## 1170 REPUBLICAN STREET

MUP Recommendation: DPD #: 3024575  
2018.03.14

1170 REPUBLICAN STREET / MUP RECOMMENDATION MEETING

## MASSING OPTIONS AND RELATIONSHIP TO NEIGHBORING CONTEXT:

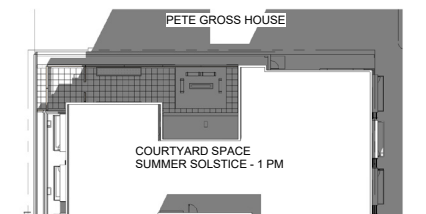
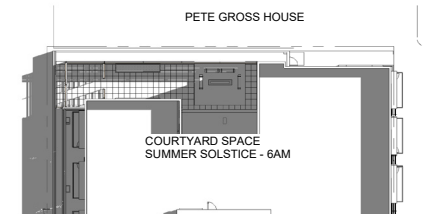
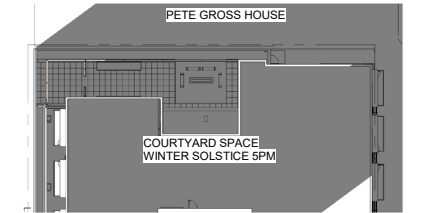
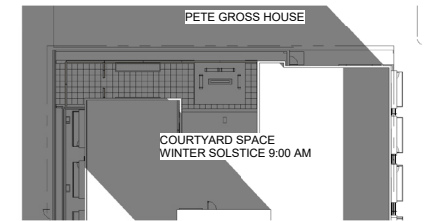
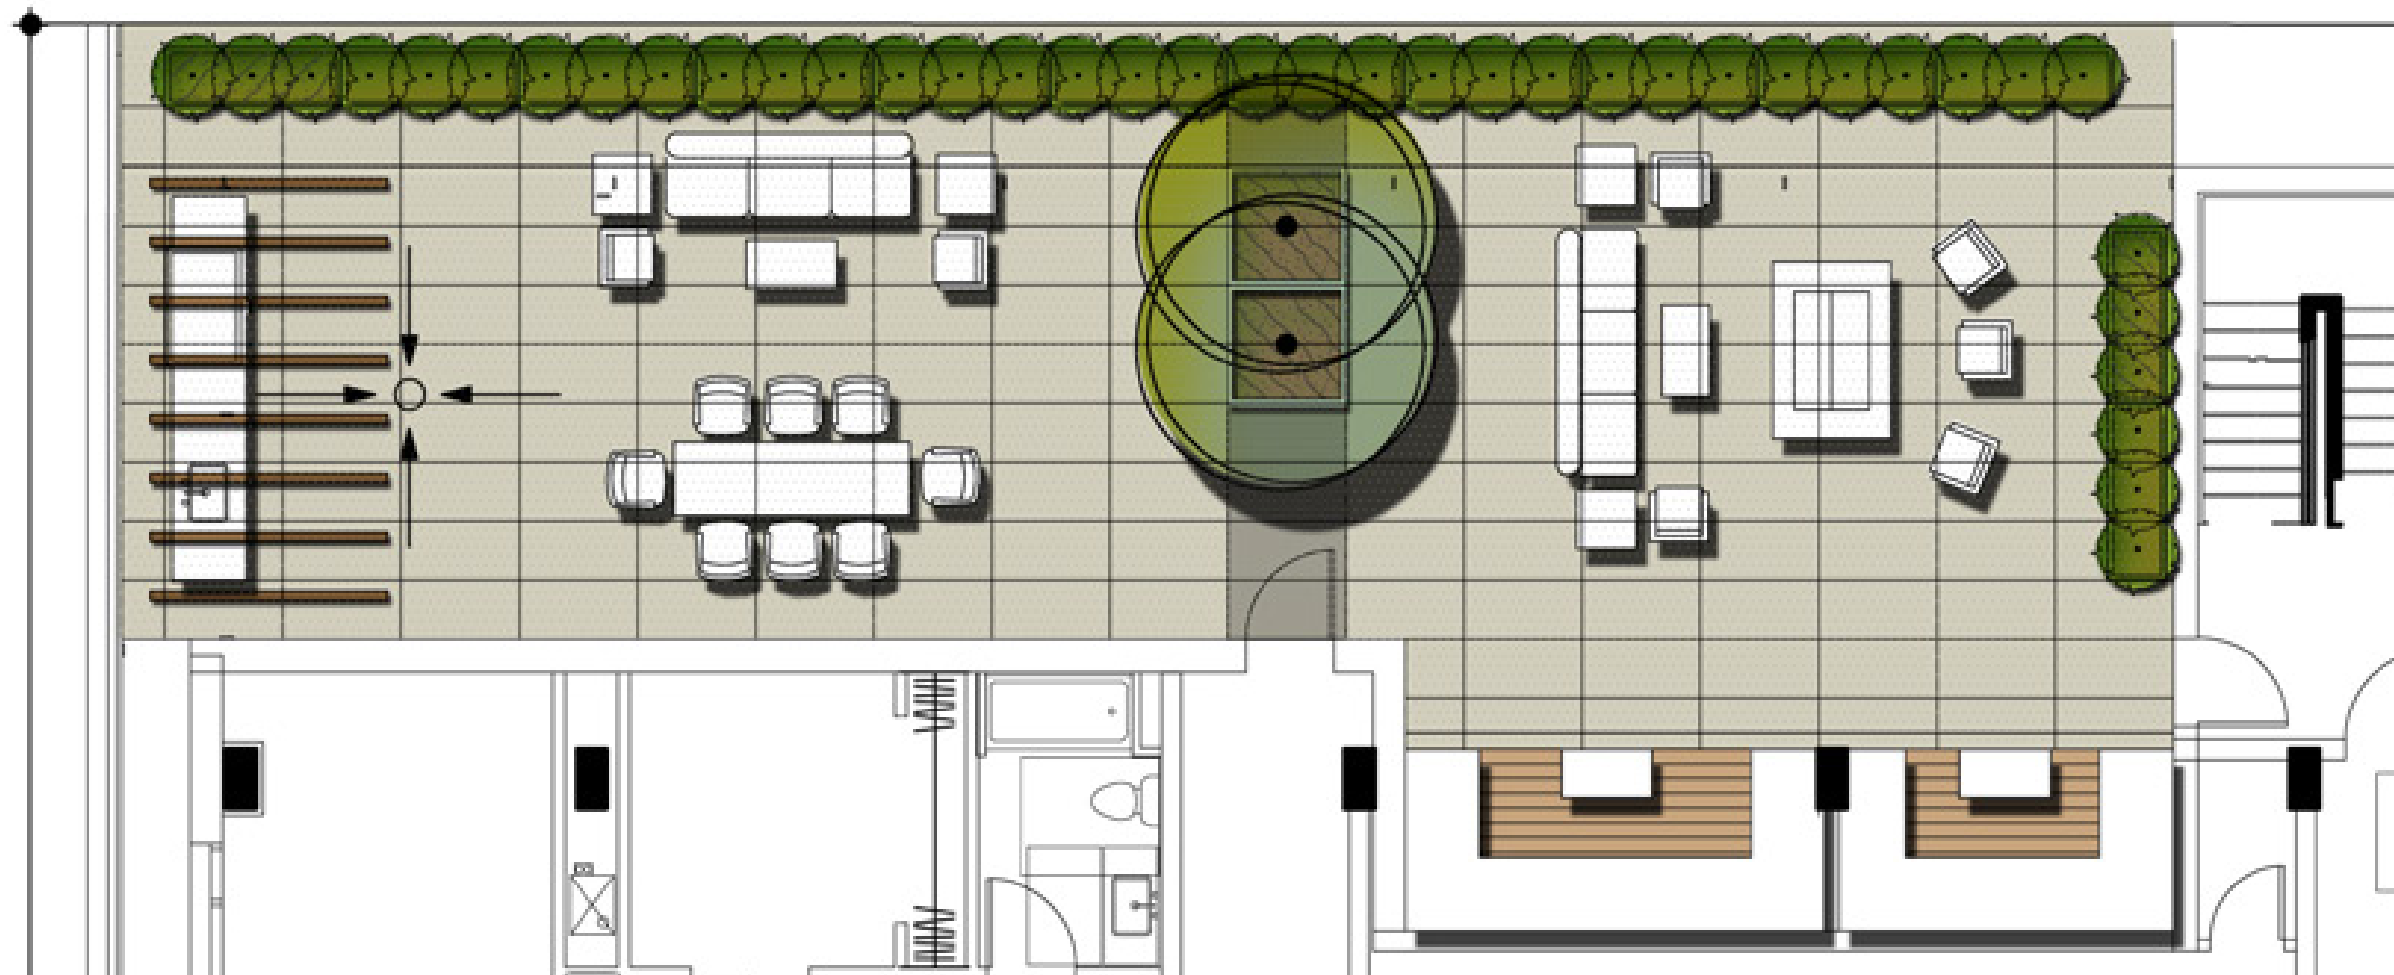
At the EDG meeting, the DRB supported the addition of a courtyard to maximize daylight and ventilation for the adjacent Pete Gross House and recommended studying the courtyard proportions to be shallower and wider, to create the best opportunity for light and air access.

Demonstrate that the design creates the best opportunity for light and air access. Provide shadow studies and include any alternate courtyard configurations studied in the draft packet.

We heard the board's feedback and have developed both a shallower and wider courtyard concept than before. We have provided more space for the outdoor amenity and given greater width between us and the neighboring building. We are also seeking to design the functions with screens and some overhead elements so as not to provide too much noise/distraction to our neighbors. Step lights are proposed to minimize glare to the neighbor along with downlights from the trellis element at the BBQ area.

## STREETSCAPE; GROUND LEVEL ARRANGEMENT OF USES AND ENTRIES:

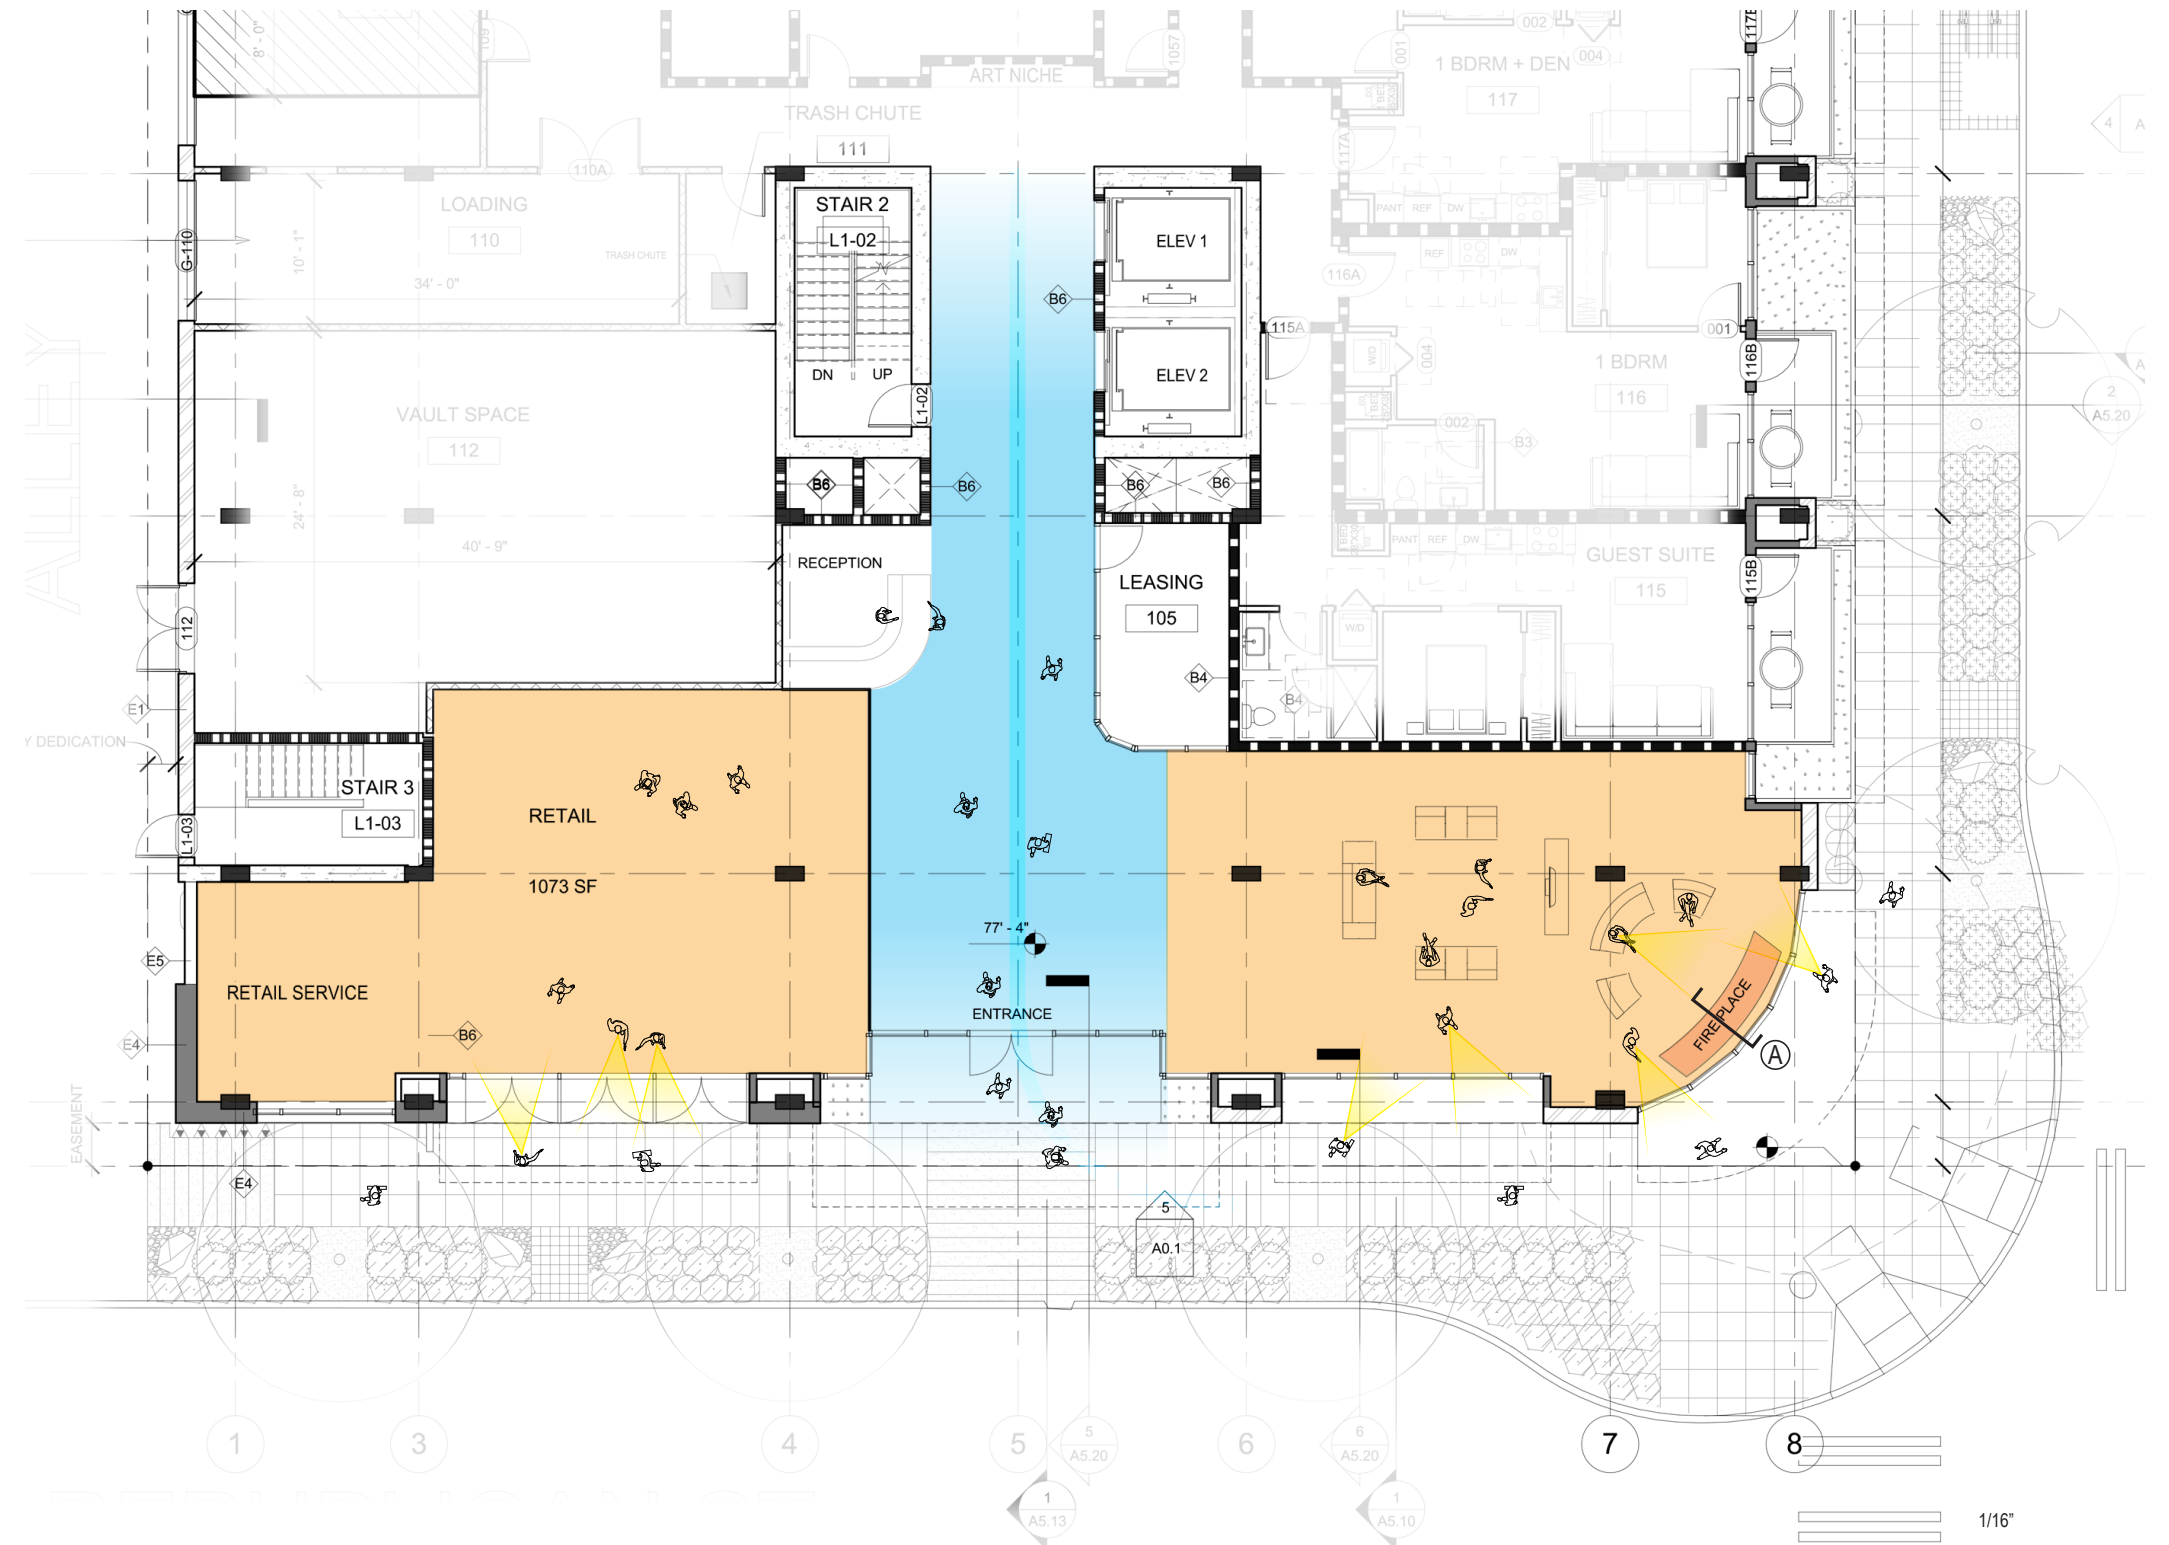
The DRB agreed that the arrangement of uses at the ground floor should be reexamined to provide a stronger connection to the public realm.

Relocating the fitness space is a significant step in the right direction. Clarify how the new uses contribute to the streetscape and pedestrian experience; include more information about the egg workspace, mixing lounge, easing/meeting areas and how these spaces will contribute to the public realm.

The DRB also encouraged relocating the main entrance to the corner. In the draft packet, provide an alternate study of an entrance at this location.

Related to this corner, the base curve does not align with the upper massing. It's difficult to determine the success of this massing shift with 2-D elevations. Provide pedestrian level renderings/sketches with more detail. Demonstrate a compelling and well-integrated expression.

The fitness space has been relocated to level 2. The ground floor facing Republican now shows a retail space. The intent for this space is a small coffee shop, bakery, etc. We are seeking a use that will promote steady foot traffic throughout the day and create a more interactive environment with the street frontage. The storefront will have many openings and during the appropriate seasons could be left open to provide even better connections particularly during times when pedestrians are more prevalent. The large glass areas will provide great visibility and visual connections for when the weather is less conducive to opening the façade further.

The entry has been located at the center of the Republican facade as we feel that an entry at the corner will only increase the interior circulation space and will be more "dead" than active workspace. We propose a fireplace at the corner of Republican and Minor. This fireplace will activate the corner by drawing people toward it both at the interior and exterior. People lounging and working in this space will contribute to the public realm.

We also envision that there is a potential interior connection between lobby / retail / amenity. Opening this up means that the entire frontage along republican is open between and through almost as an extension of the street

## STREETSCAPE DESIGN/LANDSCAPE:

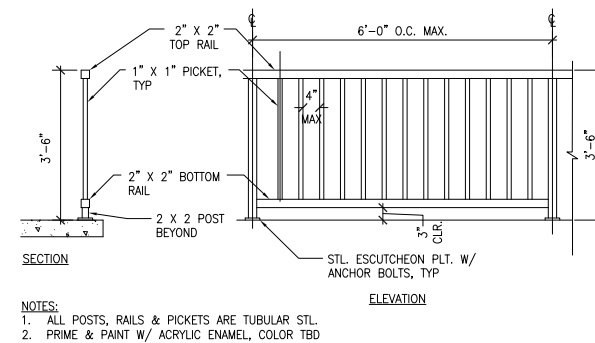
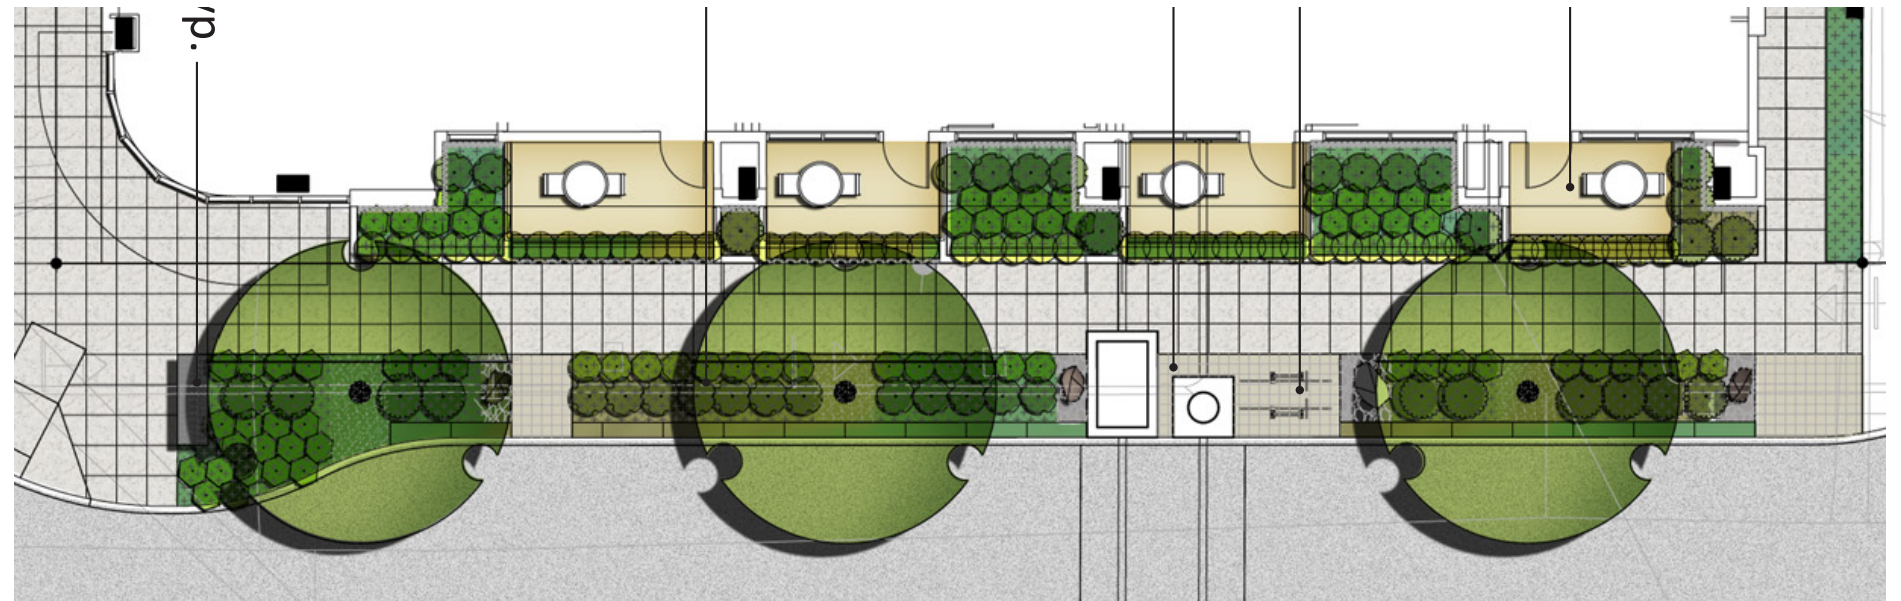
It's not yet clear how the residential frontage along Minor transitions to the adjacent Pete Gross colonnade. Refine and develop the design with pedestrian level perspectives. While developing the design consider additional outdoor seating and/or extending landscape buffer.

Clarify the materials and detailing of the residential frontage. On the landscape plan (sheet L1.00), provide more information (material, color, etc.) on the residential frontage gates, raised planters, etc.

We prefer to have patios at each of these entries. We considered a couple options along this frontage. (1) Where units enter from the sidewalk through a gate. (2) Where the patio is enclosed.

We prefer the 2nd option. Our primary goal is to make these spaces as usable as possible. If we make this an entry point, more space goes to circulation and it becomes more of a public space than a space where the resident can engage with the public. The grade changes will require a step or two which also further chops up the space, making it less functional.

We are proposing a low wall and plantings to create the necessary buffer for a resident to feel like they have ownership of the space but low and enough that it does not detract from potential social interaction.

As for the relationship to the Pete Gross house, we have provided a landscape buffer, similar to theirs. Previously this space was covered on our property, making it dark and less inviting. We have opened it up so that we can introduce natural light into this area.

## 5. ARCHITECTURAL CONCEPT AND MATERIALITY:

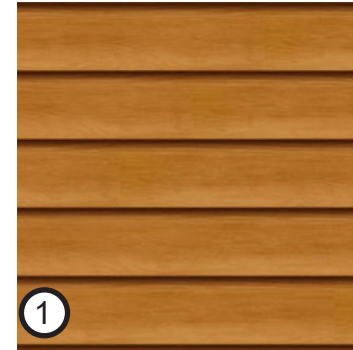
For the elevations, include more detailed material descriptions and specify color using callouts or a material legend. Clarify the type of wood siding proposed and balcony/railing materials. Also provide more information about material transitions between the wood siding and masonry.

The DRB supported graffiti art as an opportunity to strengthen the architectural expression. The response in Attachment B is noted; provide more specific information about the art, including the design concept/intent in the draft packet.

A concept of the art panels is depicted to the left. It does not represent the final design and color but we are targeting something that appears more hand made/carved.

On the interior this could literally be carved wood panels. On the exterior it may need to be more of a printed application for durability but we would look to give the image sufficient depth so that it maintained a similar character to the more detailed interior elements.

We would likely select one color and pattern but it would be pervasive throughout the interior of the project as well so that it has a richer relevance than just randomly applied panels.

## ALLEY SETBACK

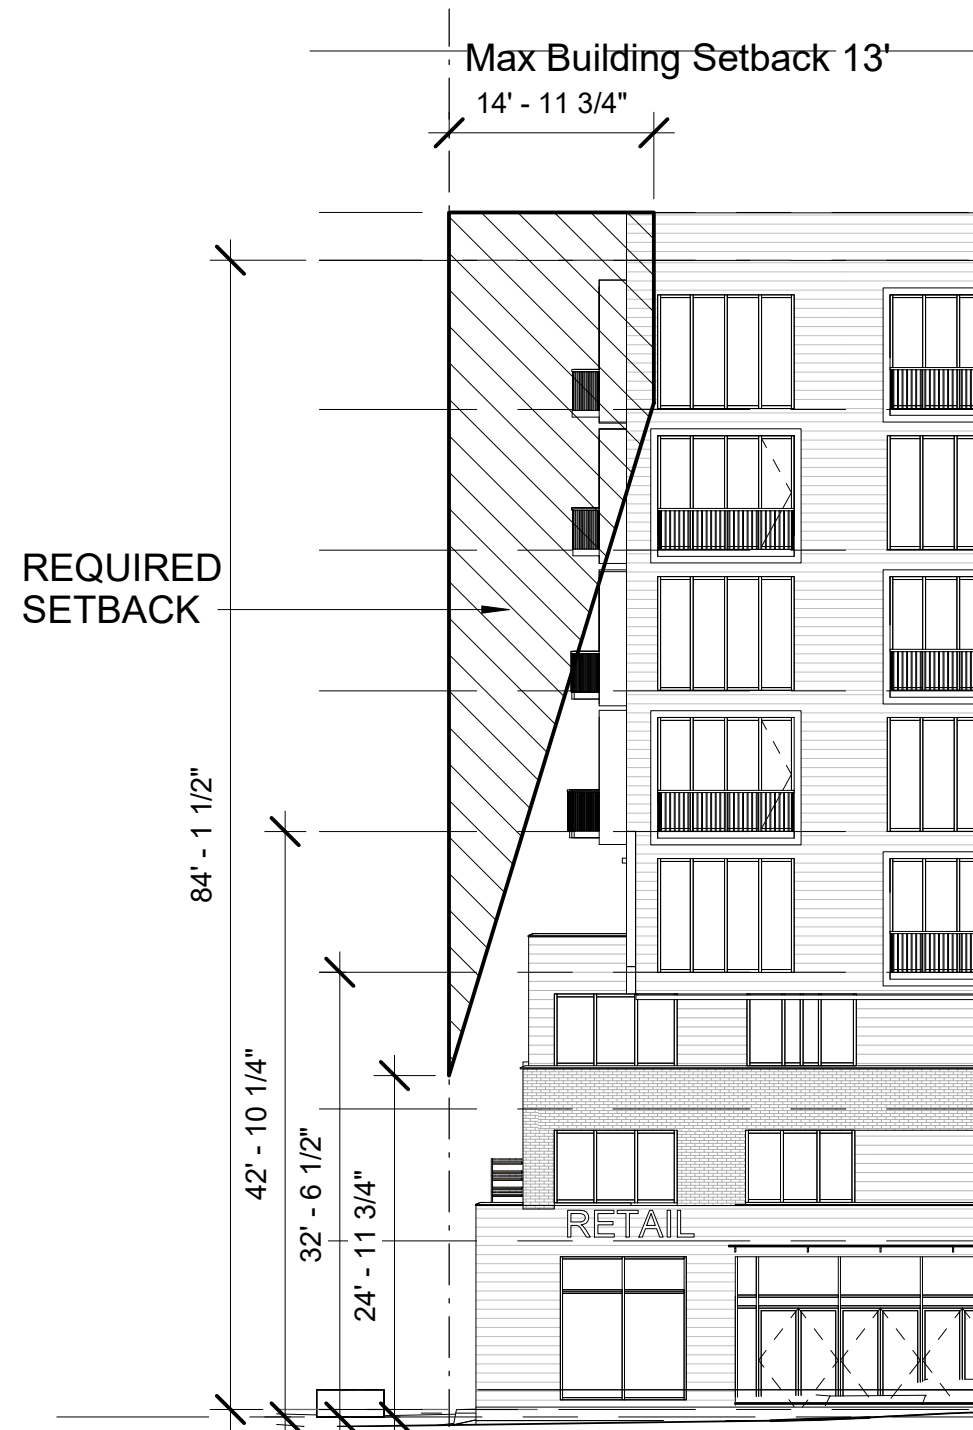
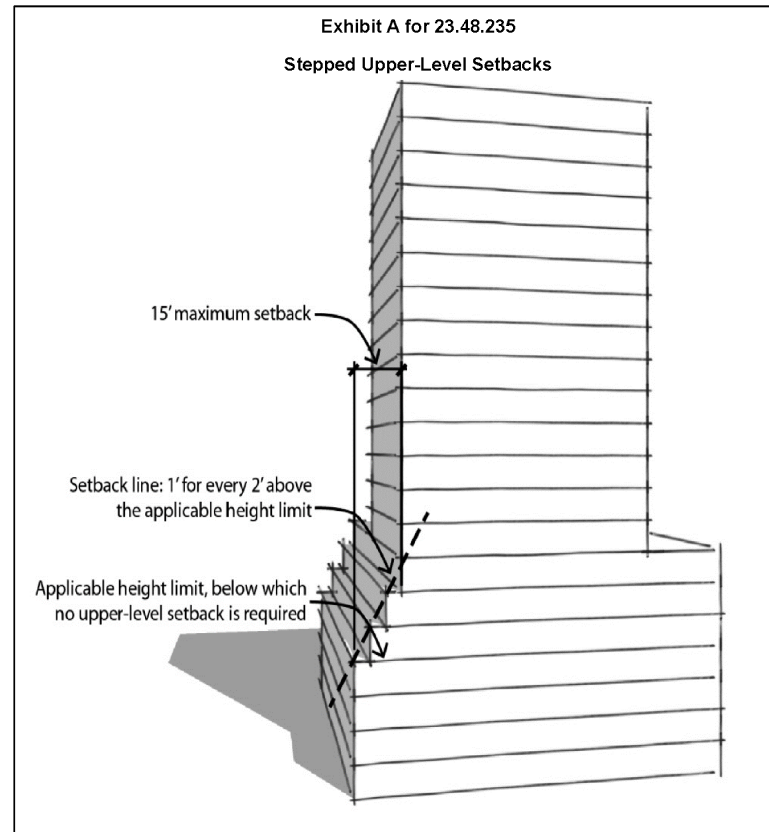
Upper-level setbacks on alleys in the SM-SLU/R 65/95 zone. For lots abutting an alley in the SM-SLU/R 65/95 zone, portions of a structure greater than 25 feet in height shall set back a minimum of 1 foot from the alley lot line for every 2 feet of additional height above 25 feet, up to a maximum setback of 15 feet measured from the alley lot line, as shown in Exhibit A for 23.48.235.

In lieu of the terraced step back we are proposing a single setback at level 3. The code required terraced approach results in an effective setback of 15' at the top of the building. We are requesting to reduce that 13'-0". Doing this allows us to maintain the strong top and podium design character and distinction. We are also able to provide more relief to a larger area for the building across the alley.
